GENERAL LAND USE APPLICATION

| Case #: | Master File #: | Date: 7/2/18 JL | | |
|---|---------------------------|--|--|--|
| Project Name: Village At Mill Pon | | | | |
| Project Description: Amendments to the Design Criteria for the Village At Mill Pond - Master Plan. See attachment for proposed amendments. | | | | |

The Village At Mill Pond Design Guidelines - Explanations

ATTACHMENT 14-A

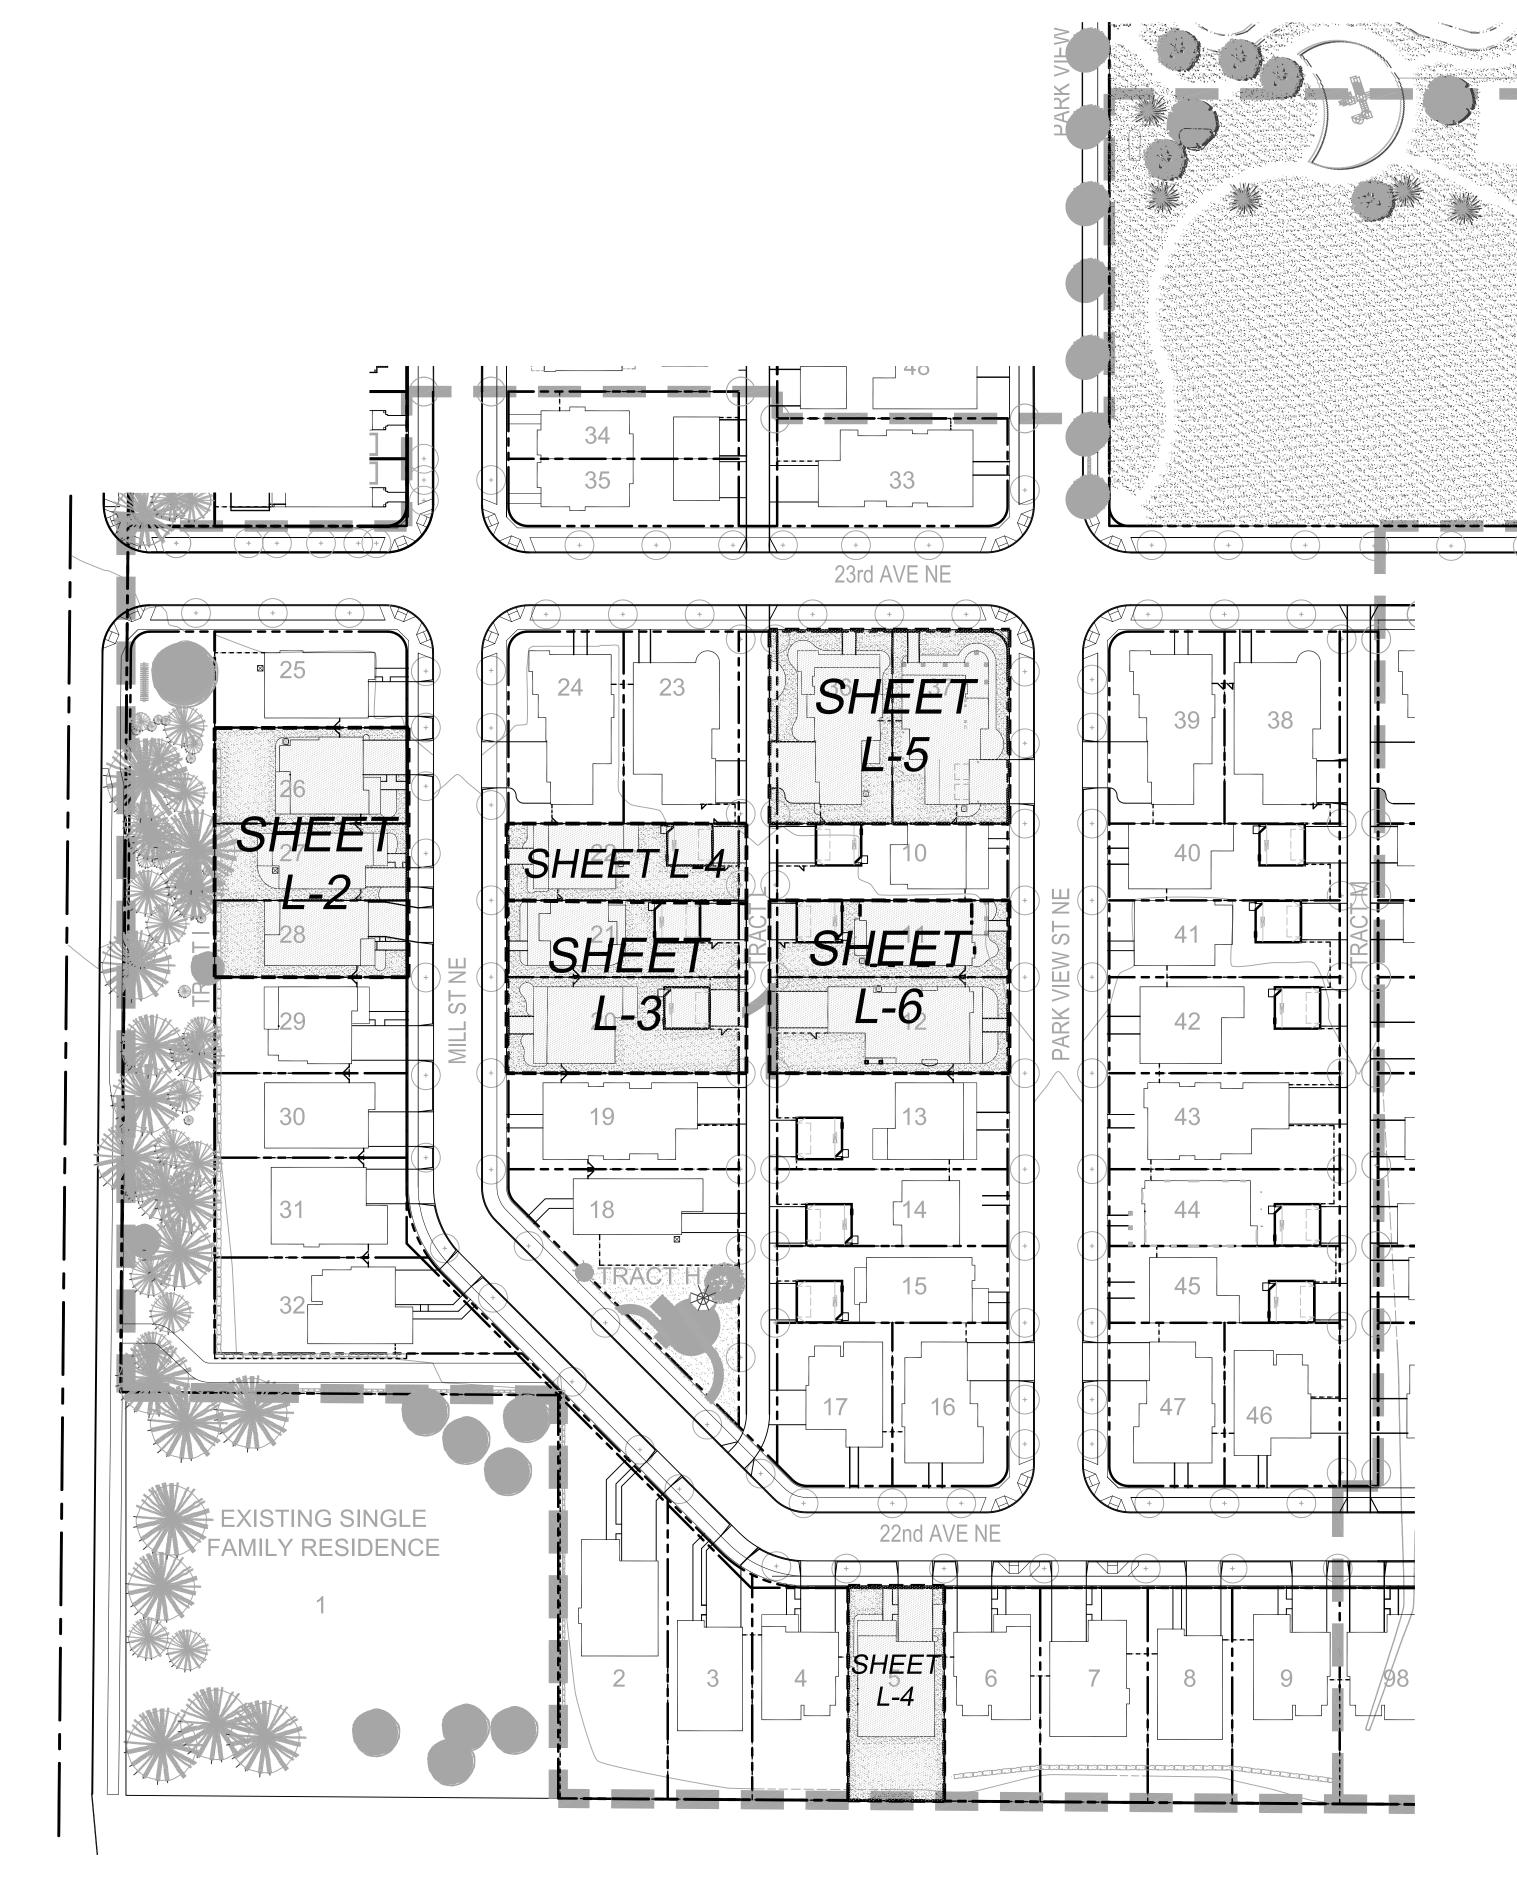
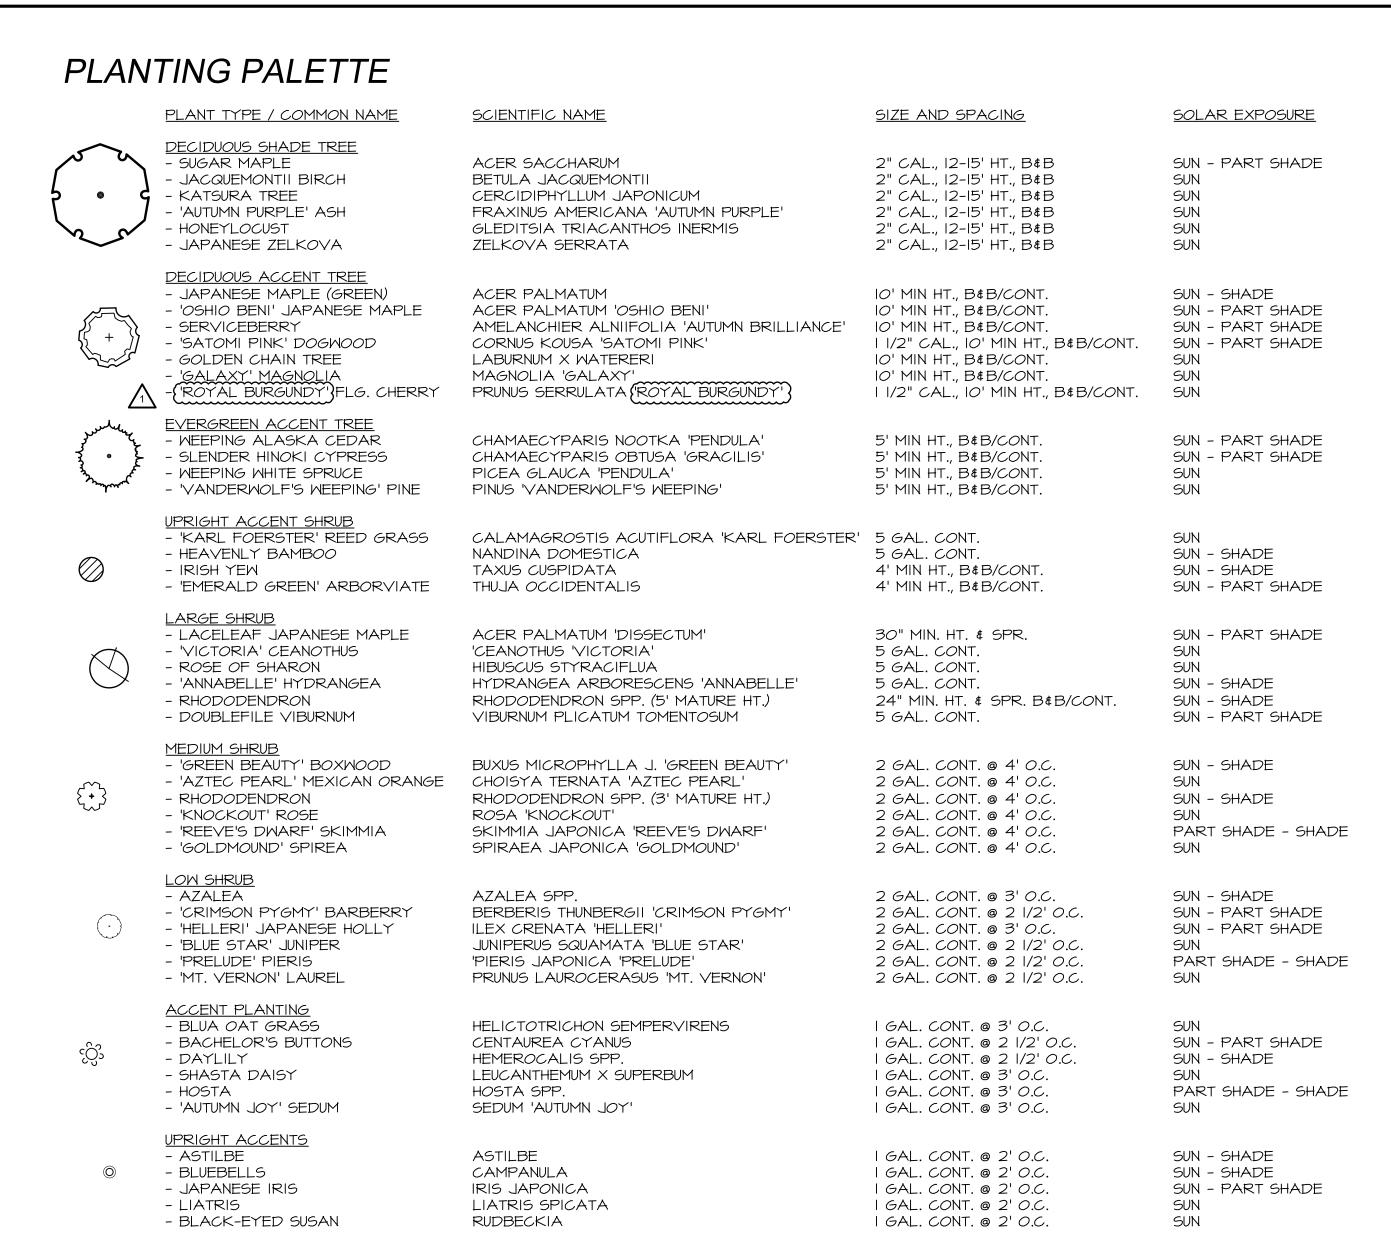
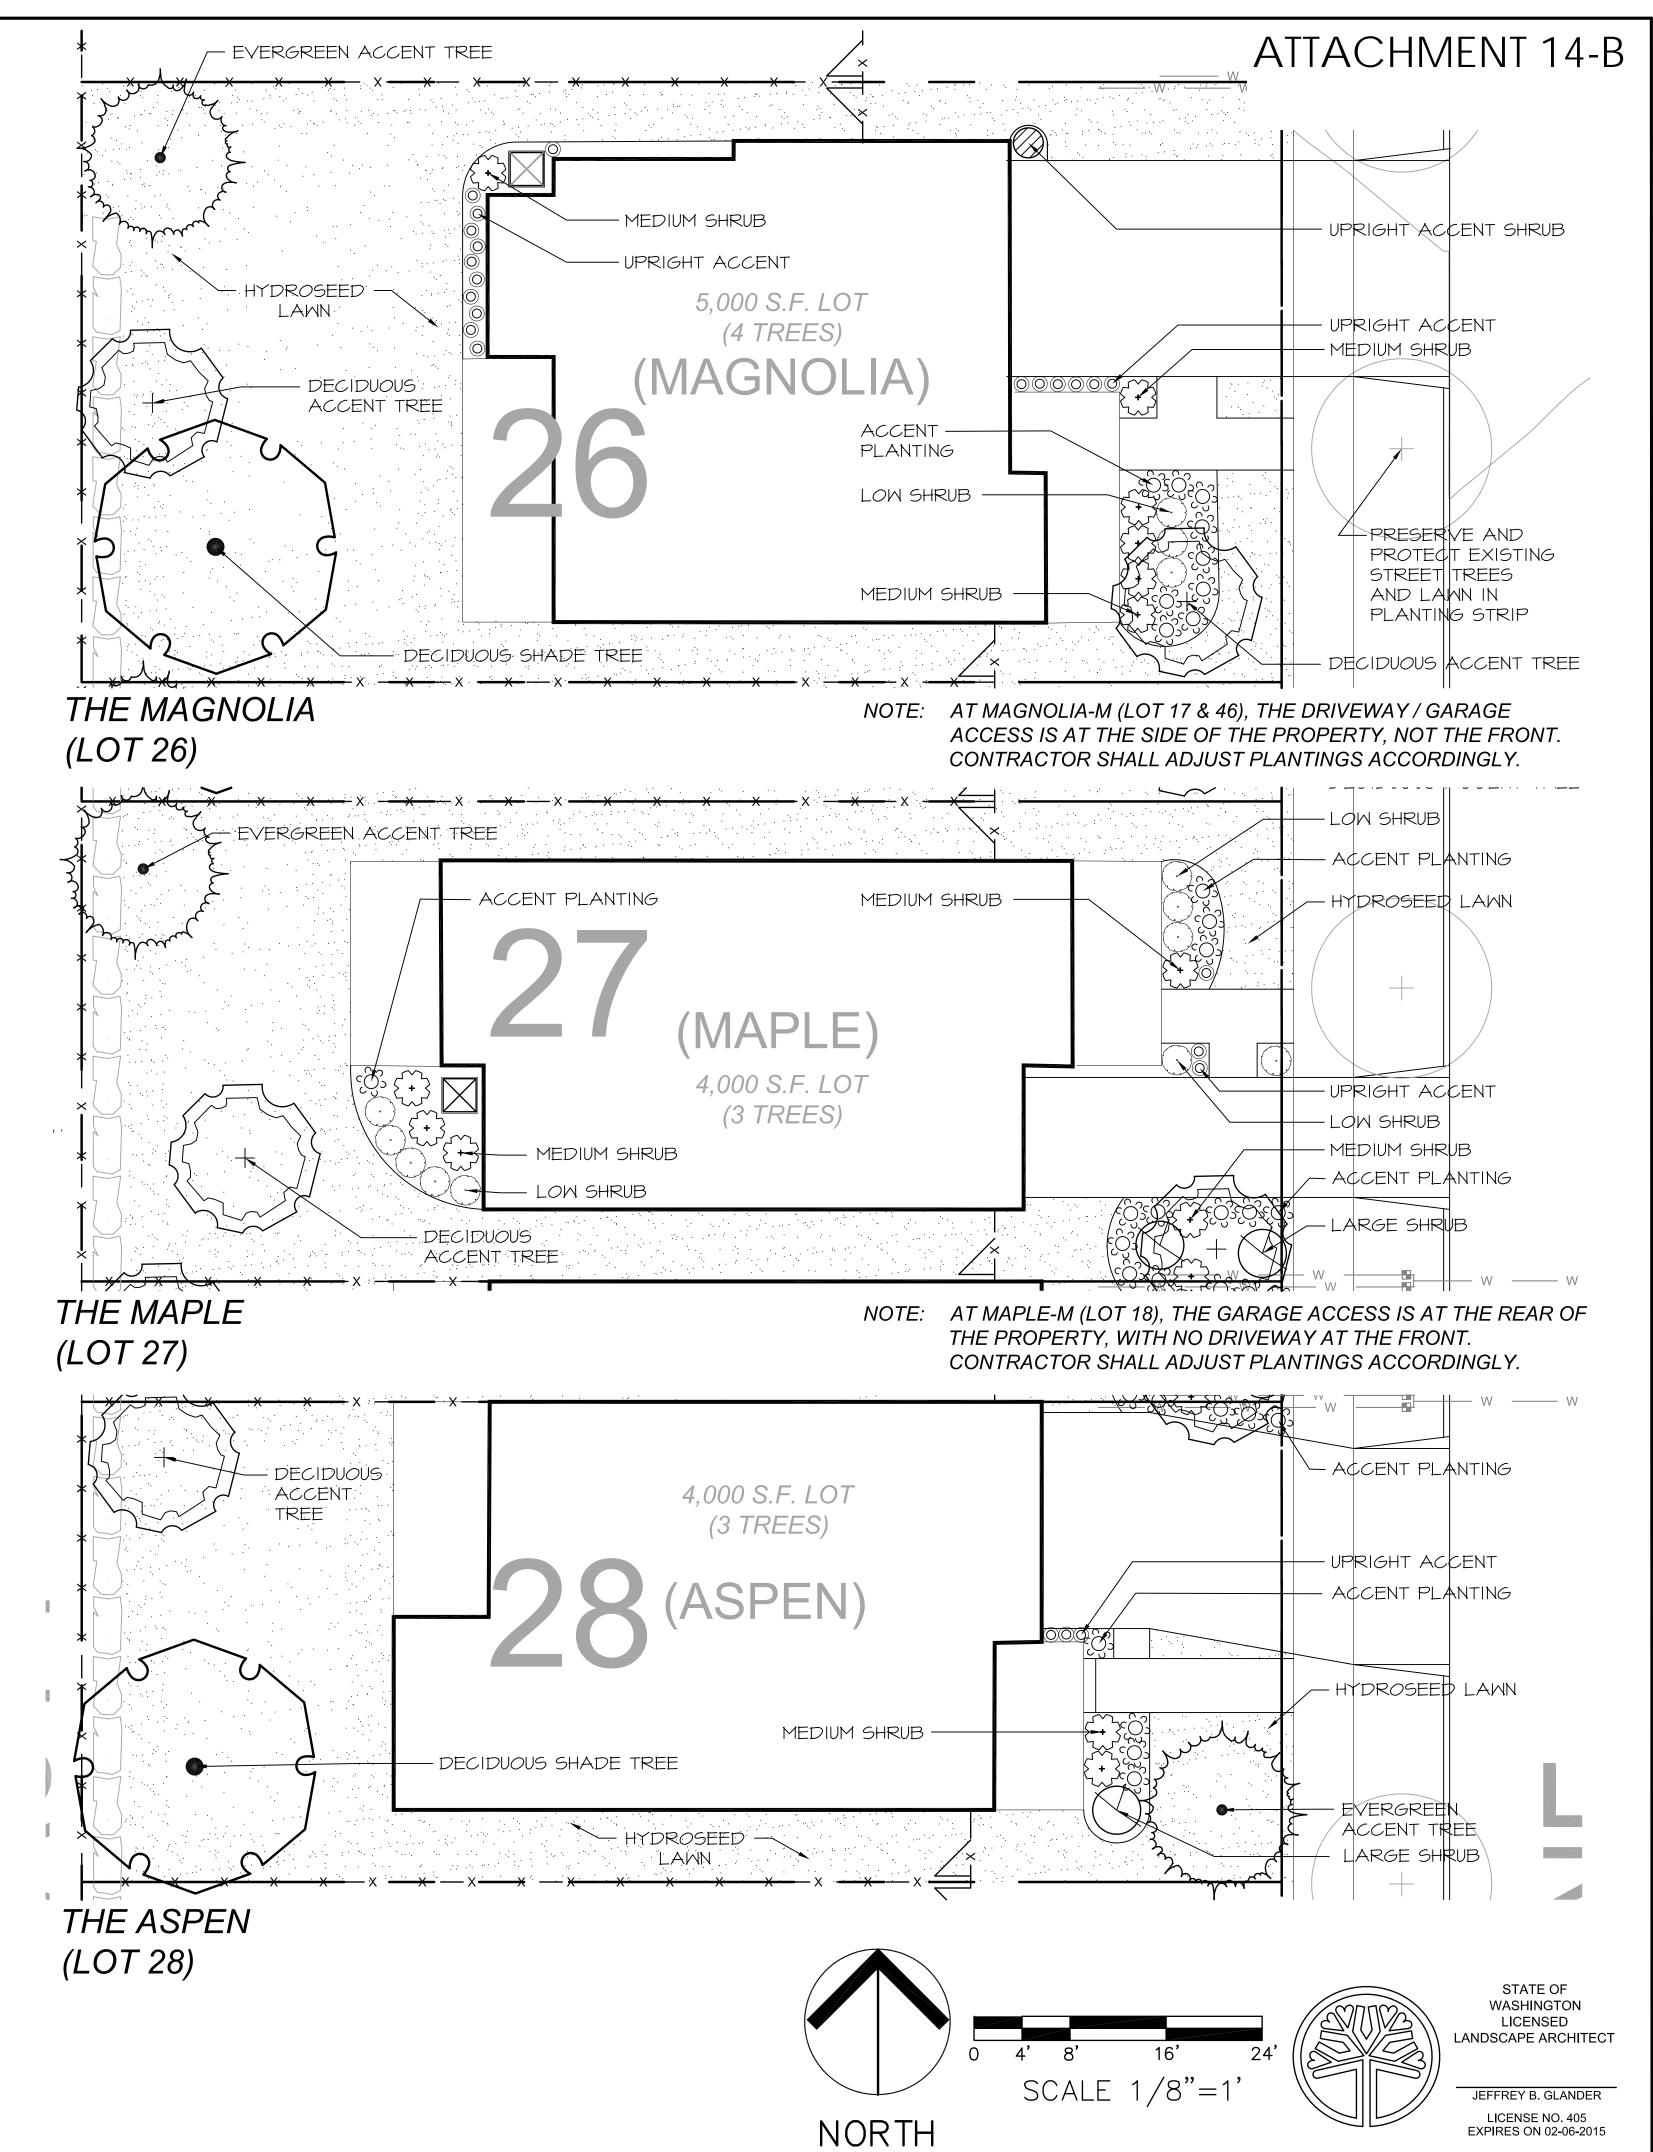
Develop landscape in layers. Low at street level and then Provide low landscaping near sidewalks, foundation plantings at foundation, with and specimen trees as intermediate layer.

This amendment clarifies the location for plantings. The intent is not to require plantings to line the entire length of the street, it is simply a criteria for size of plantings at each specific zone around the lot.

See Attachment 14-A through 14-G for example landscape plans and planting types for typical model houses
